RE: Comments – 2018 Draft Feasibility Assessment for Drayage Trucks

Please allow this letter to serve as formal comments submitted on behalf of BYD Motors LLC (“BYD”) with respect to the recently released “2018 Draft Feasibility Assessment for Drayage Trucks” by both the Ports of Los Angeles and Long Beach (“Ports”).

Re: Comments on Draft Assessment of Clean Truck Technology Released by the Ports of Los Angeles and Long Beach

Statewide Public CNG & LNG Truck Stations

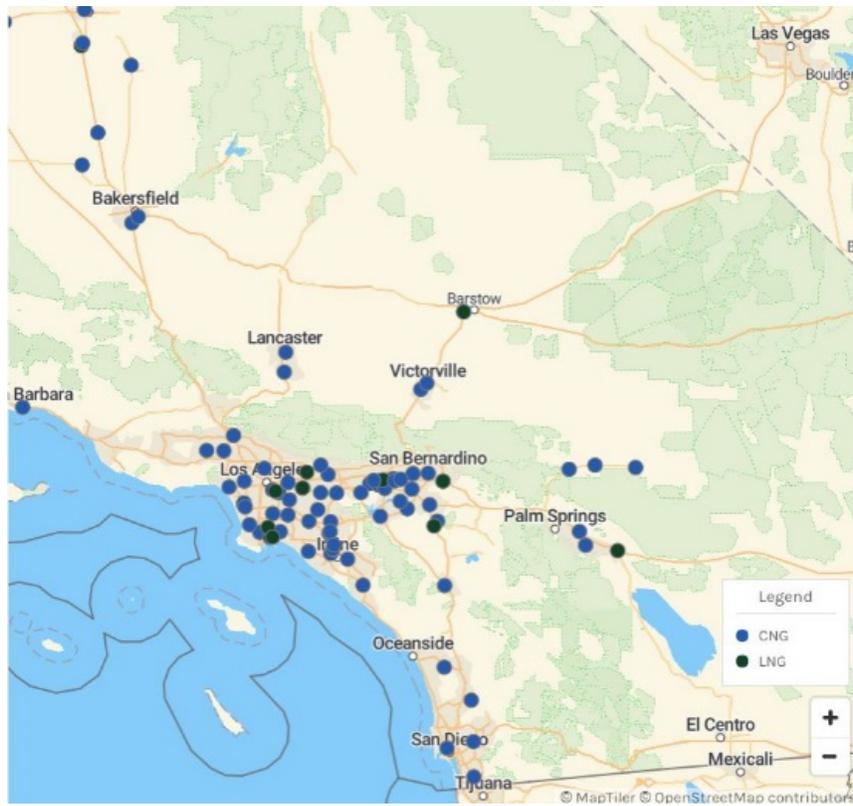
According to the federal Alternative Fuels Data Center (afdc.energy.gov), there are currently 132 publicly accessible heavy-duty truck CNG and LNG fueling stations in California. These are public stations. The count does not include private truck stations that have been deployed. Being truck stations, these stations are built in areas that service trucks. The map images below show that the stations are clustered in areas and along goods movement corridors that are traveled by trucks. The map image also shows that a good number of CNG and LNG truck stations are in Southern California areas that are traveled by port drayage trucks.

The map images above show that the NG stations have a higher concentration in the greater LA area compared to the rest of the state. Over 50 of the 132 stations are located in the four counties of Los Angeles, Orange, Riverside and San Bernardino. Natural gas fueling stations are flexible in size, design and configuration reflecting the variable needs of trucking companies. Stations range from multi-lane truck stops to single lanes. Flexibility and scalability are the strengths of natural gas fueling in meeting the many unique demands of truckers.
